**ALERT SERVICE BULLETIN**  
**REVISION NOTICE**

**SUBJECT: REVISION "A" TO ALERT SERVICE BULLETIN 206L-09-159:  
MAIN ROTOR BLADE 206-015-001-107, /-109, /-111, /-115, /-117, /-119  
AND -121 CHECK OF**

NO. 206L-09-159

**SUBJECT:** MAIN ROTOR BLADE 206-015-001-107, /-109, /-111, /-115, /-117, /-119 and -121 CHECK OF.

Figure 1. Radiograph with Blades Installed.

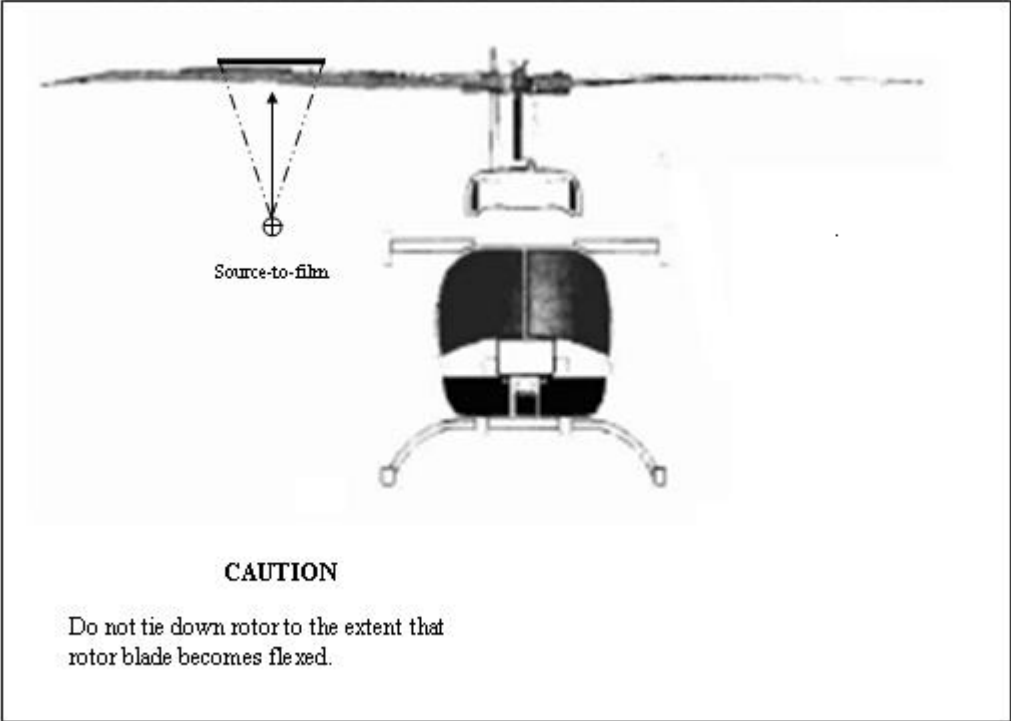
2. Blade installed on helicopter.
  - a. Rotate the blades perpendicular to the tailboom, refer to Figure 1.
  - b. Stabilize the main rotor blades to prevent movement and film distortion.
  - c. Due to the static droop and pitch angle of the blades, care must be taken to ensure the center of the X-Ray beam stays perpendicular to the bond line, refer to Figure 1.
  - d. Inspect affected blade per above step 1. b. to 1. f..

Figure 2. Cross Section of Main Rotor Blade.

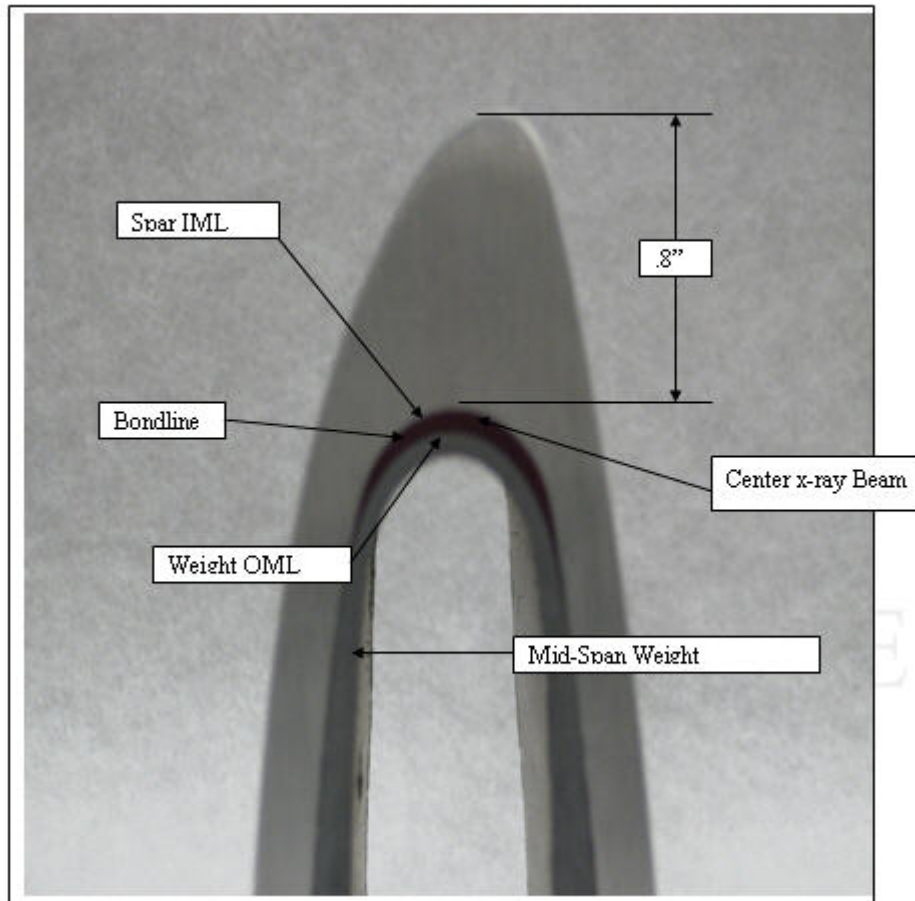
- b. The blade shall be X-Rayed at the bondline in the radius of the mid-span weight, refer to Figures 1 and 2, from station 90 to station 145, refer to Figure 3.

- e. Align the X-Ray beam perpendicular to the blade lower surface and center the beam 0.8 inch from the leading edge, refer to Figures 1 and 2.
    - f. Process the films and return them to Bell Helicopter for review.

**Figure 3. Main Rotor Blade Area to be checked.**

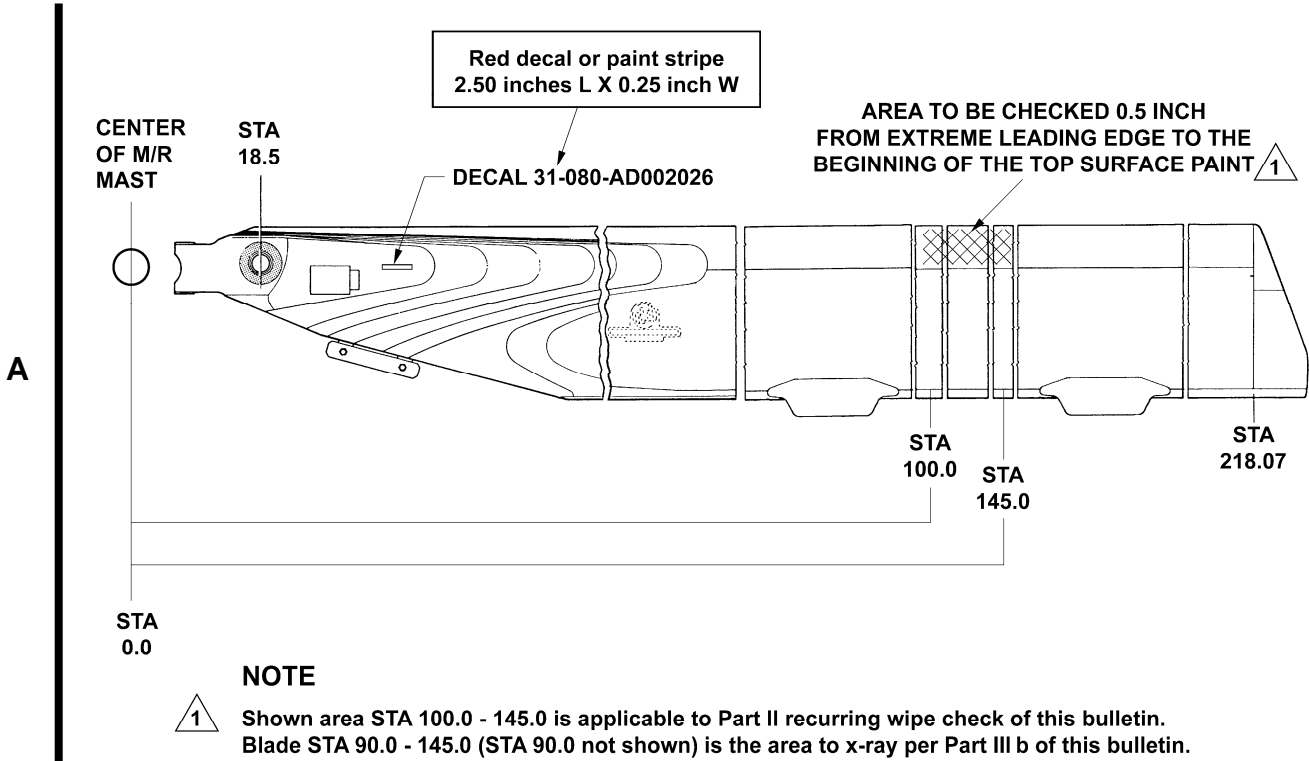
- Addition of a statement to advise owners/operators that they can contact their local Bell Helicopter Customer Service Facility (CSF) for NDI/NDT capability.
- The reference to the MIL spec for the blue food dye has been removed and the terminology has been changed for "blue food coloring".
- The requirement for NDI/NDT personnel qualification is changed from level III to level II.
- To ensure that the complete area to be checked is captured on the radiographs, the area to be x-rayed is now localized between stations 90 and 145 inches. (Previously 100 to 145 inches).
- To Introduce a note determining who can accomplish the main rotor blade wipe check.

The marking of the spar at station 100 and 145 is required for accomplishment of Part II of this bulletin. For accomplishment of Part III b, the X-ray must be taken between stations 90 and 145 to ensure the complete section between stations 100 and 145 is captured.

- a. The center of the blade bolt is blade station 18.5 (blade station zero being at the center of the mast). Use a permanent ink marker and make marks at blade stations 100 and 145. Refer to Figure 3.

- c. Blade stations can be located by placing a measuring tape at the center of the blade bolt hole. The center of the blade bolt is blade station 18.5 (blade station zero being at the center of the mast). The blade should have marks at stations 100 and 145 previously made in Part I. Refer to Figure 3.
